PART C RESIDENTIAL DEVELOPMENT ASSESSMENT SHEET

4X Single Storey Modular Homes – Lot 104 (No.27) Currall Street, NAREMBEEN 6369 - (DK – NA2026/008)

DA Information			
Address:	Lot 104 (No.27) Currall Street, NAREMBEEN		
Development description:	4X Single Storey Modular Homes		
Application received:	15/06/2026	Owner	CEACA LIMITED
Assessment start date:	24/06/2026	Applicant:	MODULARIS PTY LTD
Estimated cost of development (\$)	\$1,905,502	TPS 2 Zoning:	Residential
DA Reference Number:	NA2026/008	Land Use	Vacant
Lot area:	2,258m ²	R-Code:	R30

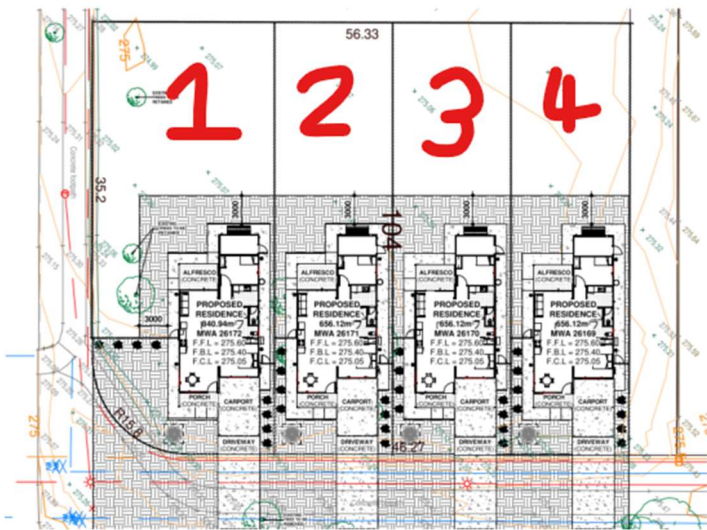
The development has been assessed as a grouped dwelling because it does not meet the definitions of

- **Single bedroom dwelling:** All the homes have more than one bedroom
- **Small dwelling:** All the homes exceed the 70sqm max internal floor area (109.4sqm)
- **Aged or dependent persons' dwellings:** exceeds the maximum 100sqm internal floor area (109.4sqm) and doesn't specify the occupants as aged or dependent people

The development is assessed with the each individual lot boundary because upon completion the dwellings act as standalone single dwellings.

As per clause **4.2 Modification of R-Codes**, given that the lot is a corner lot and has frontages to 2 constructed roads and as per the supplied cover letter the development is capable of being connected to reticulated water and sewer. This application will be assessed under Part C of the R-Codes as 4x grouped dwellings because the lots have not been subdivided, it is noted that upon completion of the project the dwellings will act as standalone structures.

As a reference the following dwellings and lots have been classified based on the numbers below.
